Appendix B

Responses to NRC Questions

Page
Responses to Questions on GESTAR II Revision 5	US.B-3
Responses to Questions on the Barrier Fuel Amendment (Amendment 6)	US.B-113
Responses to GESSAR II Questions Regarding SRP Section 4.2	US.B-120
Responses To Questions On The Fuel Loading Error Analysis (Amendment 28)	US.B-126
Responses to Questions on Additional Amendments (References)	US.B-136

Figure 5.1.1-4. Relative Bundle Power Histogram for Actual Power Distribution

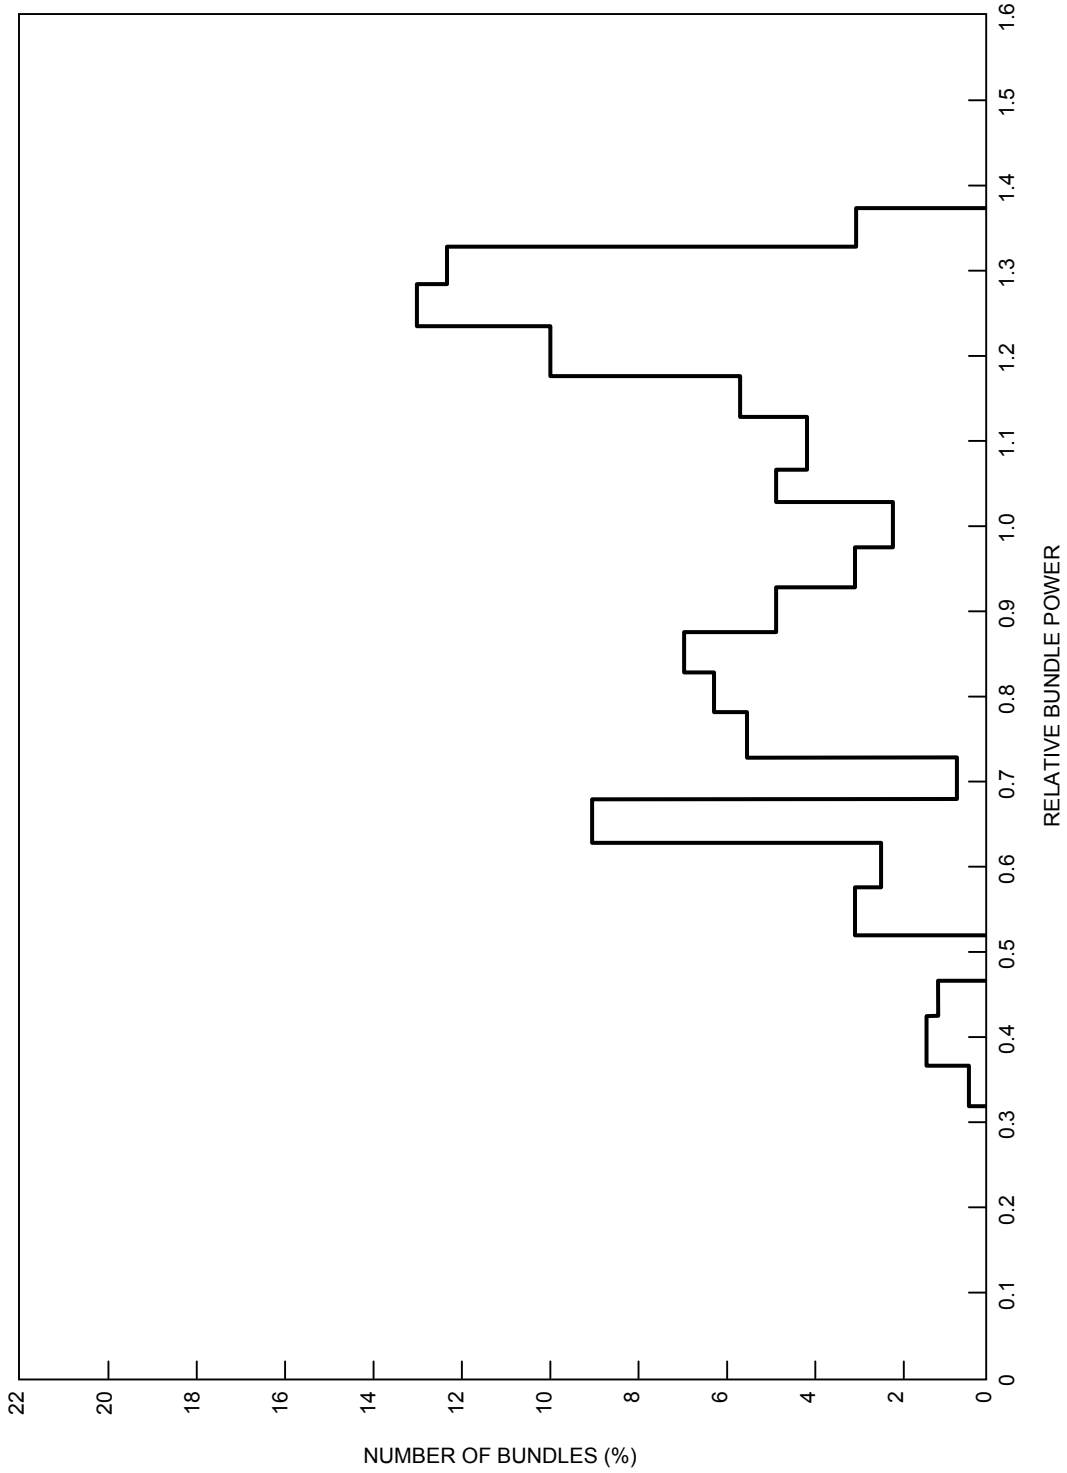
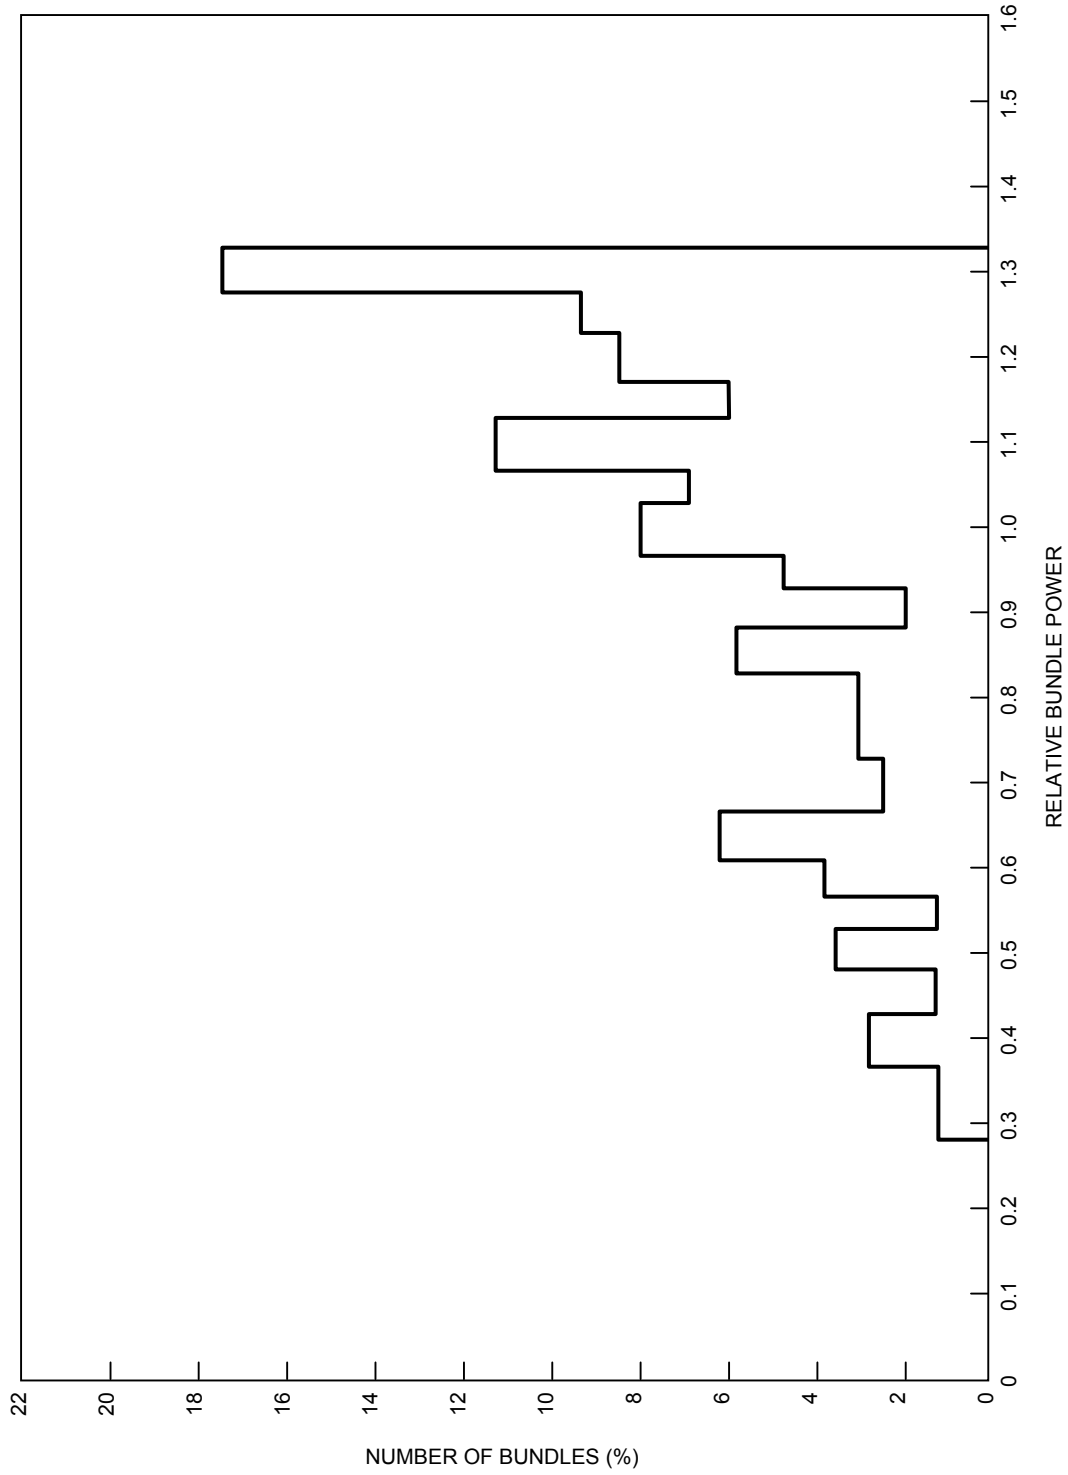
Operating Plant Data:	
Core Power:	3252 MW (99% rated)
Operating MCPR:	1.25
MCPR Operating Limit:	1.25
Radial Power Distribution:	Figure 5.1.1 4
The 99.9% Statistical Limit MCPR:	1.00
Design Basis:	
Technical Specification Safety Limit MCPR:	1.05
Design Basis Power Distribution:	Figure 5.1.1 5

Figure 5.2-1. Effects of Initial MCPR on ΔCPR Typical BWR Core

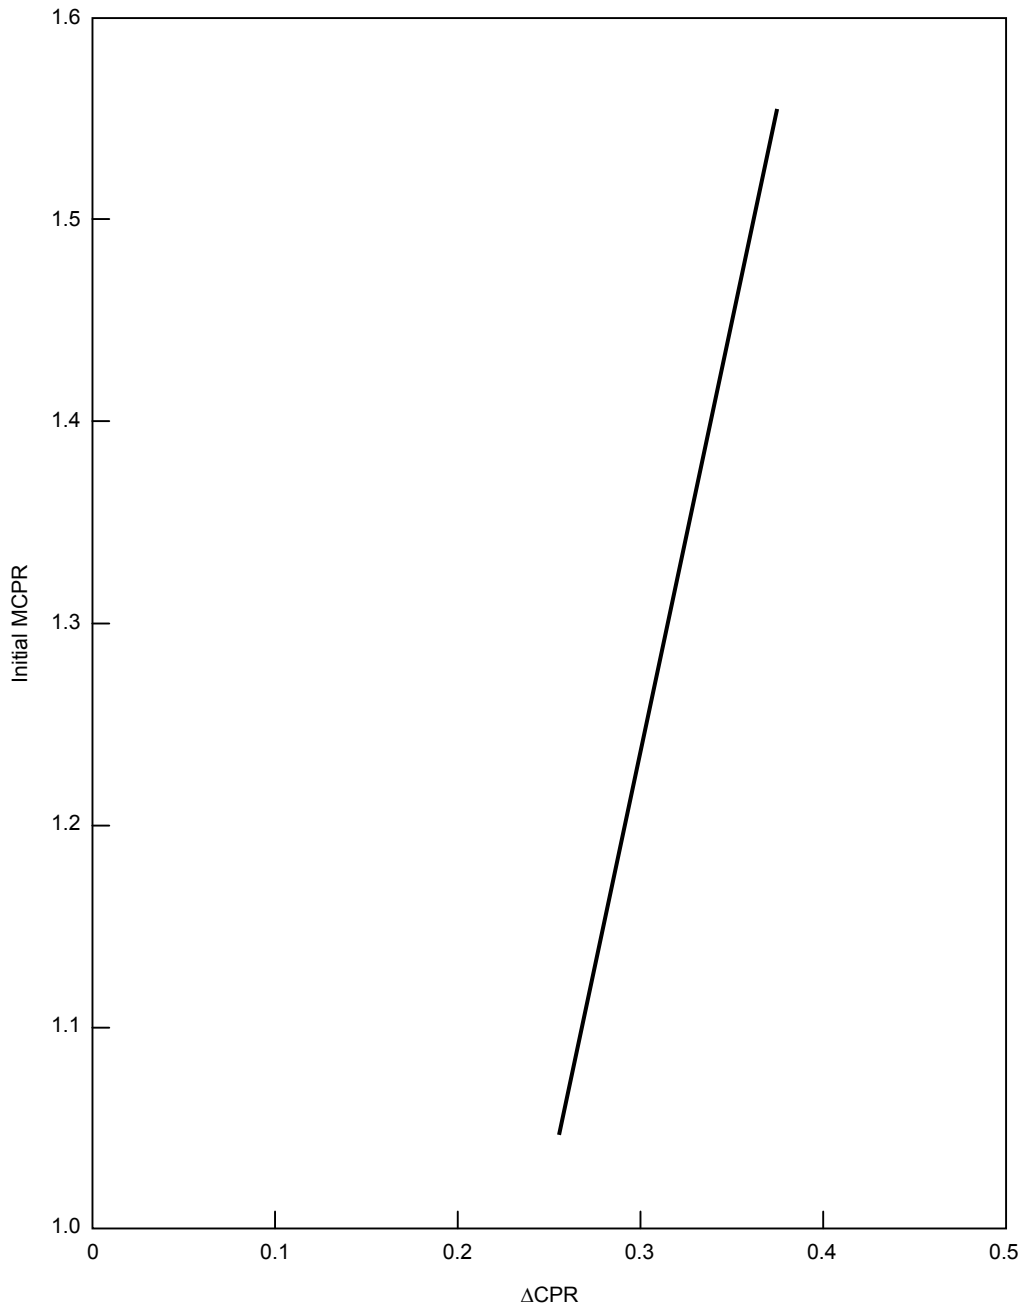
The initial MCPR assumed for transient analyses is usually greater than or equal to the GETAB operating limit. The attached Figure 5.2-1 illustrates the effect of the initial MCPR on transient Δ CPR for a typical BWR core. This figure indicates that the change in DCPR is 0.01 for a 0.05 change in initial MCPR. Therefore, in some cases, nonlimiting GETAB transient analyses may be initiated from a MCPR below the operating limit because the higher operating limit MCPR more than offsets the increase in Δ CPR for the event. This may also be applied to limiting transients if the difference between the operating limit and the initial MCPR is small (0.01 or 0.02).

Figure 5.2-2. BWR/2-4 Power-Flow Map

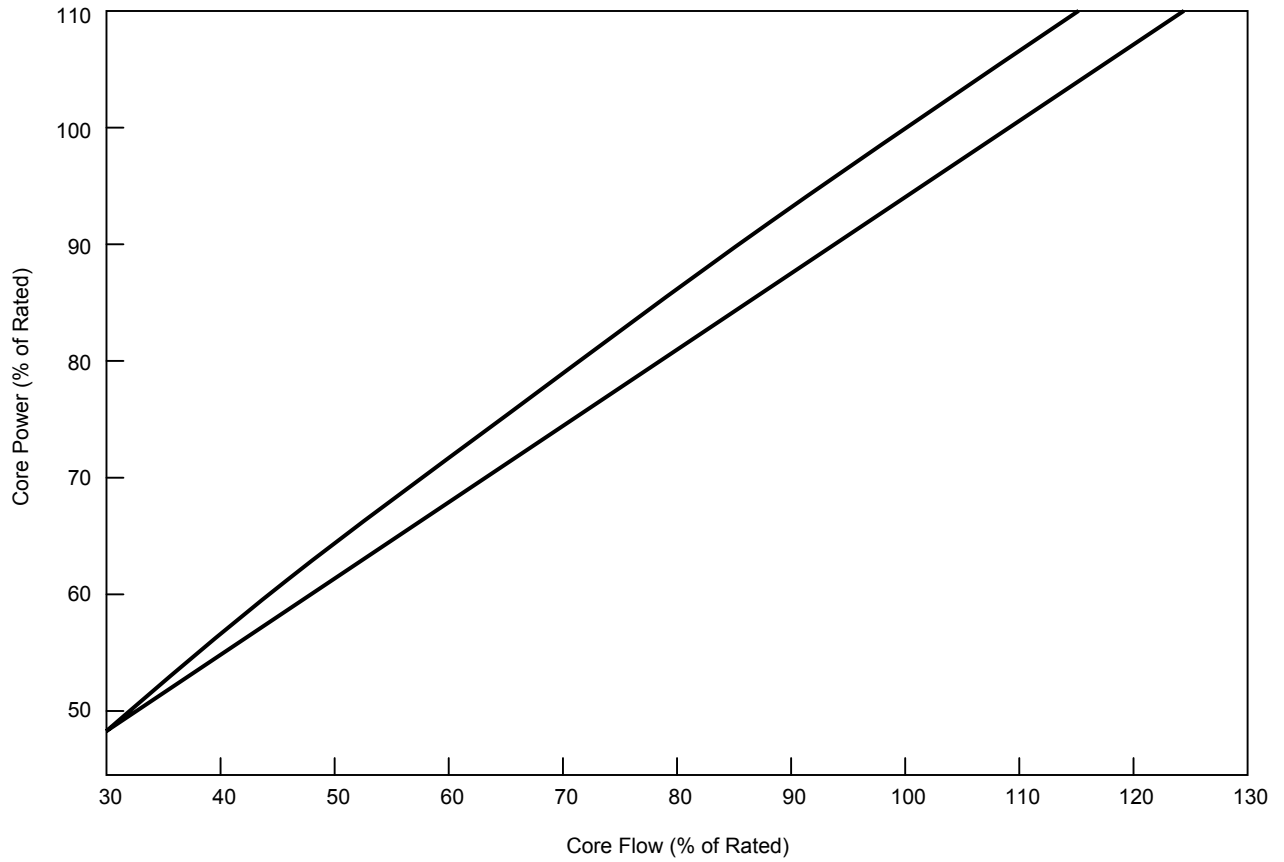
The power-flow relations used in this example are provided in Figure 5.2 2. Pertinent core parameters are:

Figure 5.2-3. K_f Factor

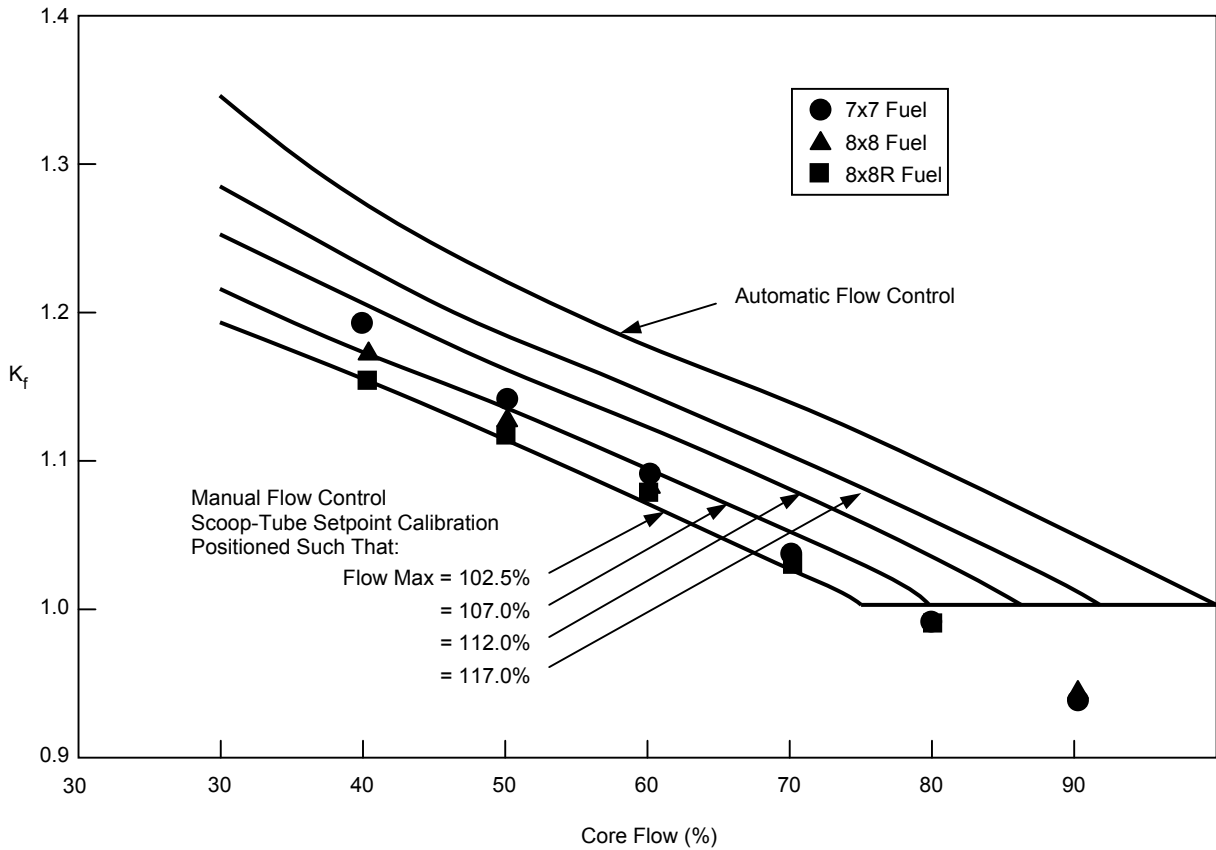
Figure 5.2-3 compares the derived 102.5% core flow K_f curve with the standard curves (Figure 5-7). These results show that the 8x8R fuel closely follows the 102.5% line, but the 7x7 fuel is 3.3% nonconservative at 40% core flow. However, the K_f curves are conservative for all cores with 7x7 operating limits greater than 1.23.

Figure 5.2.2.5-1. Typical Comparison of Exposure-Dependent MCPR Limit to Nominally Expected Limit

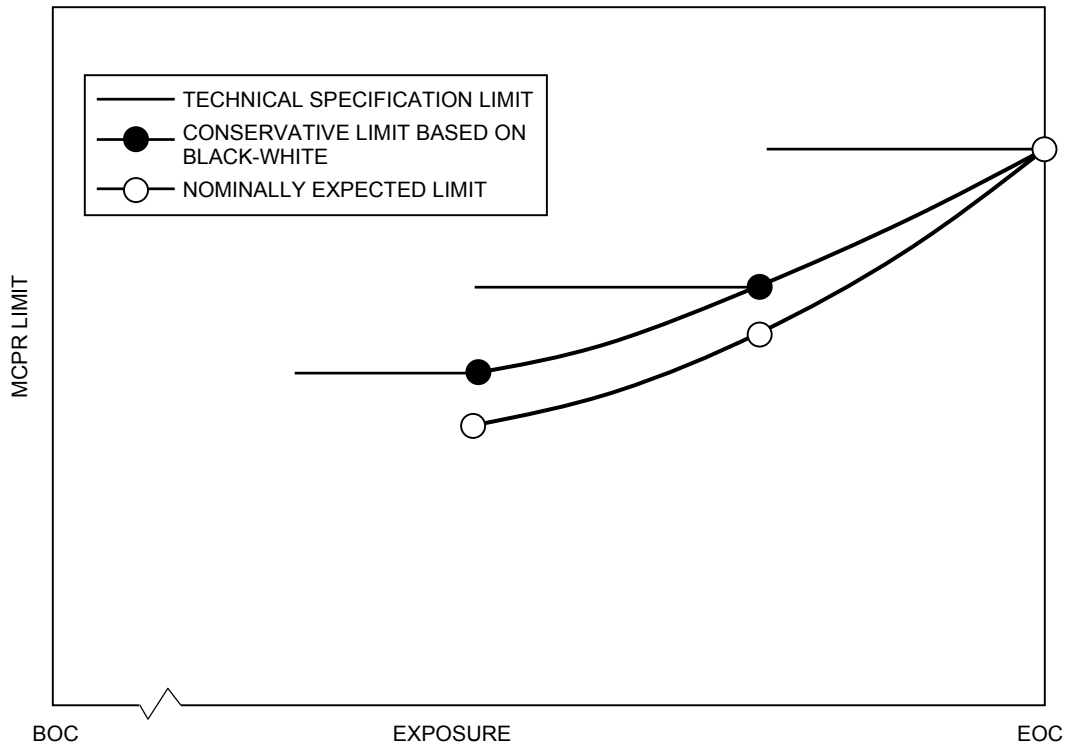
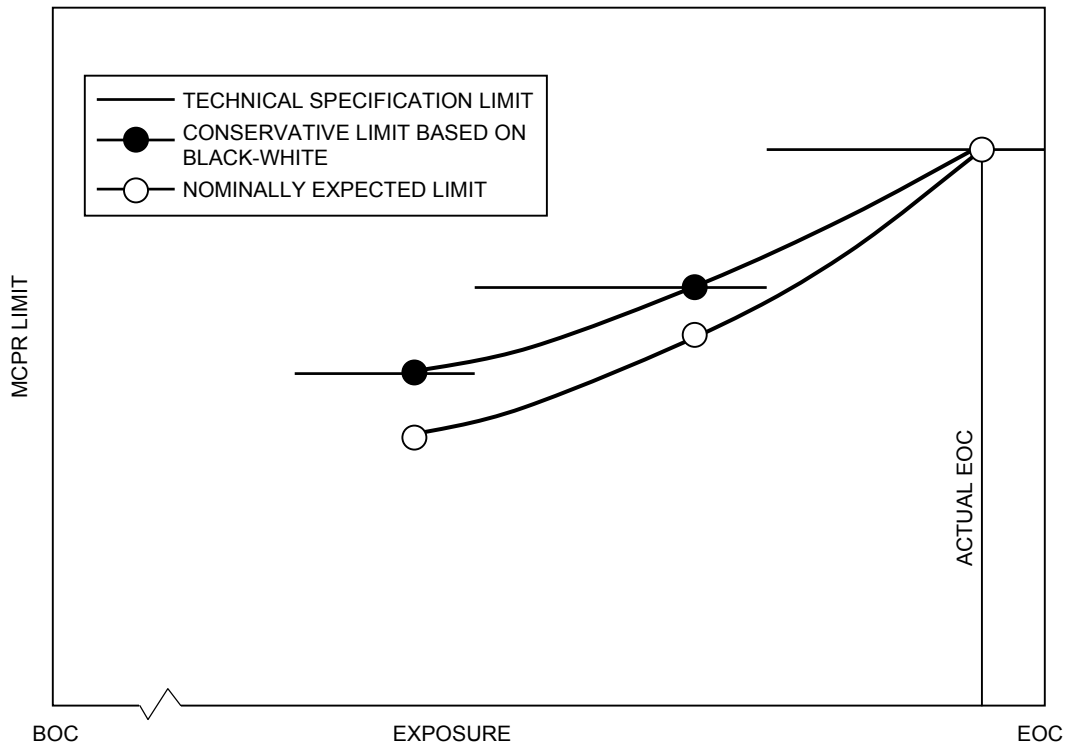
The conservative nature of the limits, as implemented, can be shown most effectively by means of an illustration. In Figure 5.2.2.5-1, the MCPR at two intermediate exposures and at EOC have been plotted as a function of exposure. The solid circles represent the results derived from the black-white rod patterns, and the open circles represent limits derived from the nominally expected rod patterns. The MCPR limit varies smoothly between these points, as shown in the figure.

The Technical Specification limit on MCPR, however, is applied as a histogram, rather than as a smoothly varying function of exposure. The MCPR limit during any exposure interval is determined by the most limiting value at either end of that interval. For the example shown in Figure 5.2.2.5-1, the Technical Specification limit would be applied as shown by the heavy horizontal lines.

- (a) The actual EOC exposure is greater than that projected. In this case, the step increases in MCPR limits shown in Figure 5.2.2.5-1 would occur sooner than actually required, and there is no potential violation of limits.

- (b) The actual EOC exposure is less than that projected. In this case, the step increases in MCPR would occur later than required, and there is a potential violation of limits. This situation is illustrated in Figure 5.2.2.5-2. Note that there are small exposure intervals just prior to the step changes in limits for which the Technical Specification limit is slightly less conservative than that derived from the black-white patterns. However, the difference between these two MCPR limits is small. Also, note that the Technical Specification limit provides margin to the limit derived from the nominally expected rod patterns for reasonable deviations for end-of-cycle exposure.

Figure 5.2.3-1. Extreme Profile

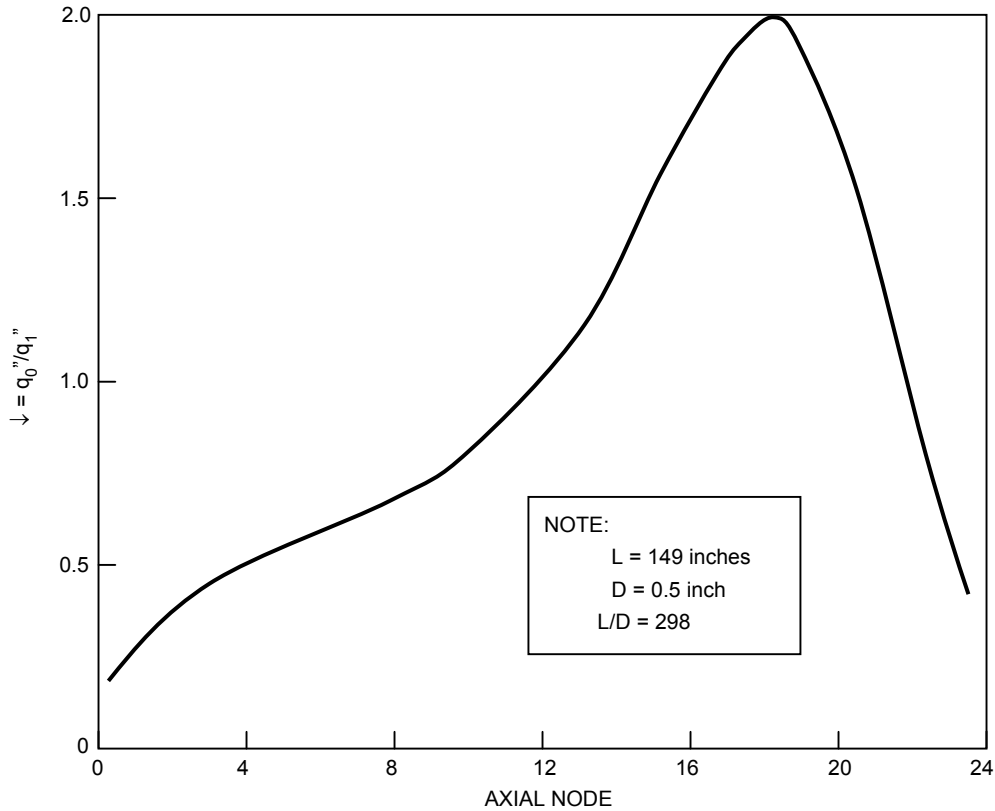
To assign a limiting value to C, the extreme BWR profile of Figure 5.2.3-1 has been selected for which $S/(P/A) = 0.015$ (no BWR profile is expected to yield a higher value of $S/(P/A)$). The other factors on the right of Equation 5.2.3-1 are $K = 5.0$ (corresponds to $P = 1000$ psia, see Reference 6), and $D = 0.5$ in. (typical for BWR's as noted in the report).

Figure 5.3-1. Effect of Scram Time on Peak Vessel Pressure

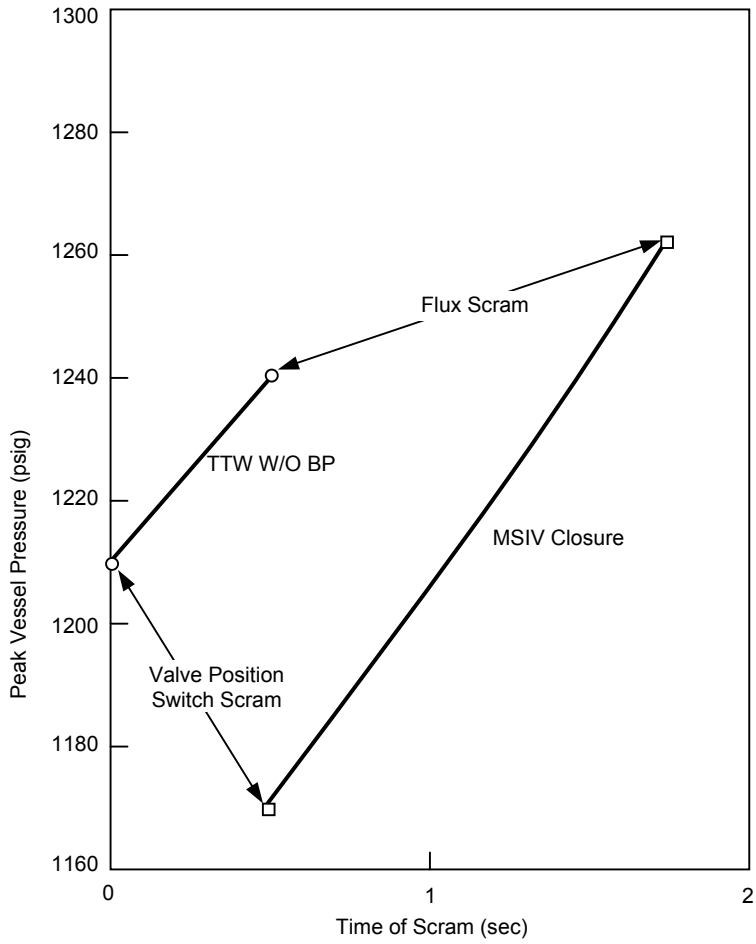
The MSIV closure event has been demonstrated in the past to be more severe than the turbine or generator trip without bypass when credit is not taken for direct scram. An illustration of the typical relationship between these events is shown in Figure 5.3-1 (attached). Limiting events which are affected by a scram trip are generally most limiting at the end of the cycle due to the dominating effect of the scram degradation in this portion of the cycle because the control blades are withdrawn from the core.
